Federal Aviation Administration
Aviation Rulemaking Advisory Committee

Task 6 – Ice Protection of Angle of Attack Probes

Transport Airplane Directorate IPHWG Tasks 5 & 6 Report

Airplane and Engine Certification Requirements in Supercooled Large Drop, Mixed Phase, and Ice Crystal Icing Conditions; Final Rule

FIGURE 1 — Appendix O, Freezing Drizzle, Liquid Water Content

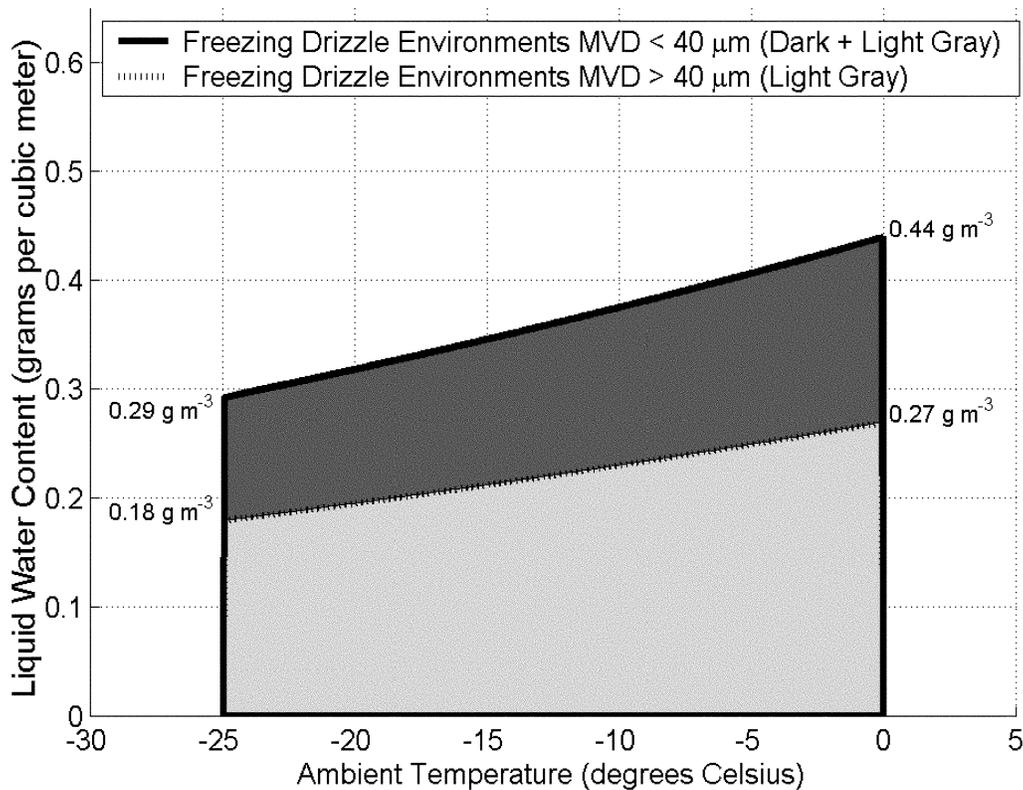
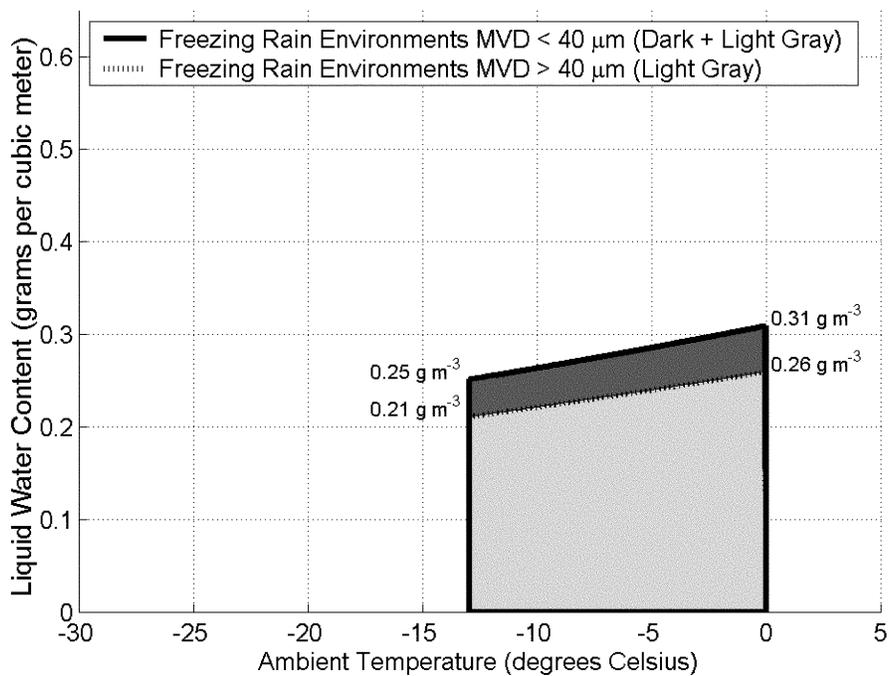
In response to other comments, figures 1 and 4 of appendix O have been revised in this final rule to reflect the LWC proposed by the IPHWG. As a result, freezing drizzle conditions with a median volume diameter (MVD) greater than 40 microns fall within the adverse region that would be identified using the University of Wyoming LWC/drop size technique. No changes to appendix O were made as a result of these comments.

Several commenters said that proposed figures 1, 4, and 7 in appendix O of the NPRM were different than what was proposed by the IPHWG, and that the FAA did not provide an explanation for those differences. The commenters also noted that the higher LWC contained in the figures proposed in the NPRM could have a significant impact on an applicant's design. GSIS specifically noted that the higher water content defined in appendix O will have

We agree. We reviewed the figures proposed in the NPRM and the data used by the IPHWG to generate the figures. We revised figures 1 and 4 to reflect the lower water content values proposed by the IPHWG, but the water content in appendix O is still higher than within appendix C at the same temperature. The higher water content may increase the power requirements for some electro-thermal deicing system designs, but not to the extent that may have been necessary with the water contents proposed in the NPRM. The environmental conditions defined in appendix O are valid conditions that will need to be considered for applicable future designs. Our review of the data used to generate the scaling factor curve in figure 7 indicates that the figure 7 proposed by the IPHWG in the task 2 working group report was incorrect; ⁴ figure 7 in the NPRM was correct. Therefore, figure 7 in this final rule remains as proposed in the NPRM. Figures 1, 3, 4, and 6 of appendix O in this final rule have been revised to identify the corner data points for clarity.

FIGURE 6 — Appendix O, Freezing Rain, Temperature and Altitude

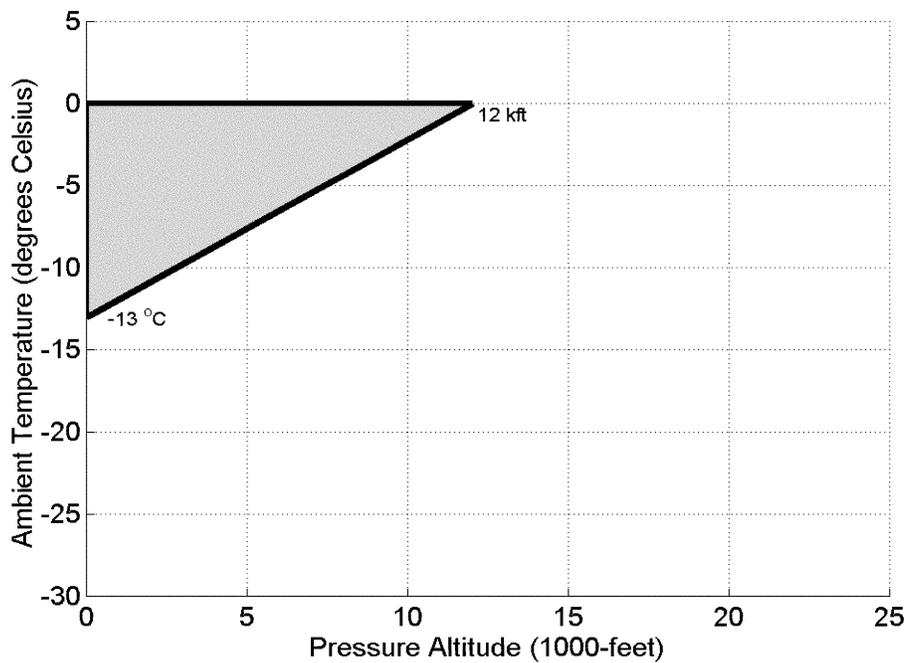
One commenter, a private citizen, noted that the NPRM did not identify the vertical extent for part 25, appendix O, figure 6. We disagree. The pressure altitude range and vertical extent for freezing rain were provided in appendix O, part I, paragraph (b) in the NPRM located under figure 3. We clarified appendix O, part I, by moving all of the general text describing the meteorological parameters, including vertical extent, ahead of the figures.

FIGURE D3 — Exposure Length Influence on TWC

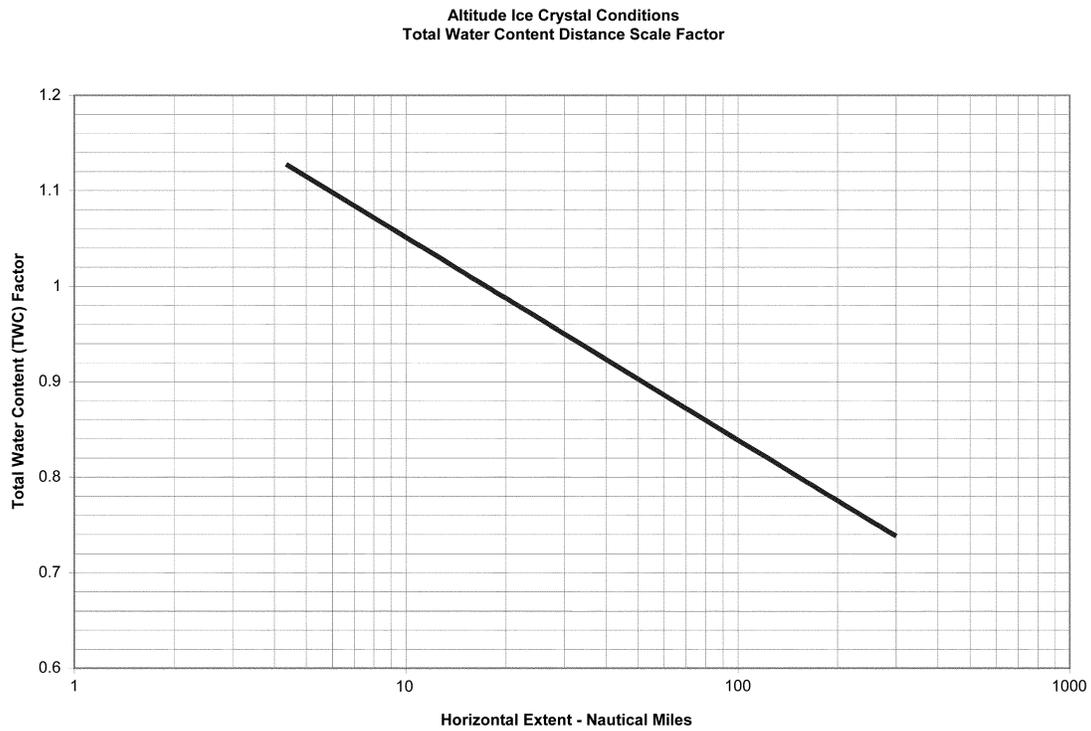
Snecma commented that the y-axis value in proposed part 33, appendix D, figure D3, was incorrect. The value should be 0.6 but the NPRM showed the value as zero.

33, appendix D, figure D3, to depict the correct axis values. The lowest x-axis value is now 1 and the lowest y-axis value is now 0.6.
